**Title:** **Draft Reply LS** on 'Cipherring of access bursts on VGCS channel'  
**Response to:** LS S3-050023 (GP-050599) 'Cipherring of access bursts on VGCS channel'  
**Release:** Rel-6  
**Work Item:** VGCS

**Source:** SA3  
**To:** GERAN2  
**Cc:** ----

**Source:** Siemens  
**Title:** Access burst ciphering for VGCS  
**Agenda item:** VGCS  
**Document for:** Discussion/Decision

**Figure 1: VGCS uplink channel access flow**

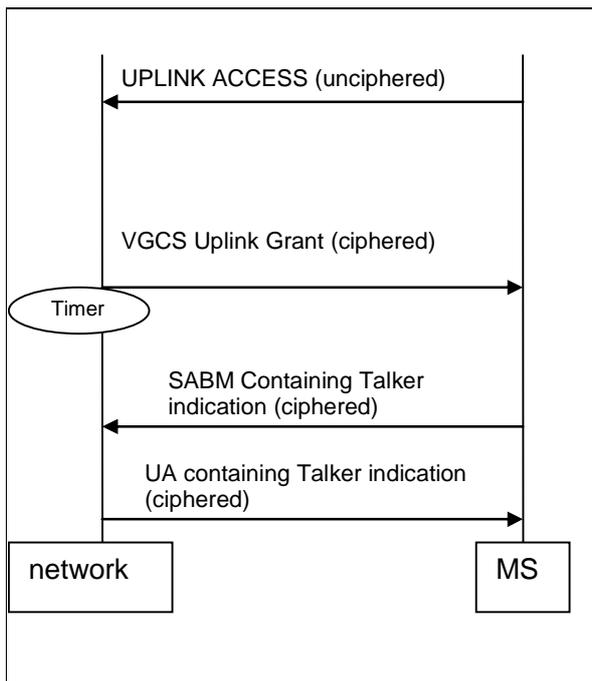
The concern that was raised during GERAN#23 is that an unciphered (i.e. not 'implicitly' authenticated by the VGCS group key) VGCS access burst for uplink access could be a potential tool for a VGCS DoS attack. An attacker (not belonging to the VGCS group) would set the emergency talker bit (a Rel-7 enhancement) within the VGCS access burst for uplink access (See Figure 1 flow), in order to try to obtain uplink channel.

However as the VGCS Uplink Grant message (which is sent back from the network to the MS) is ciphered using the VGCS group key, and the expected message back (Talker indication) are both ciphered, the attacker will not be able to grab the uplink channel (so respond successfully to the network). A couple of retransmissions of the ciphered uplink grant access message may take place. The introduced delay is dependent on the network configuration (timer value and maximum number of retransmission (Timer T3115- See Annex for a detailed description)).
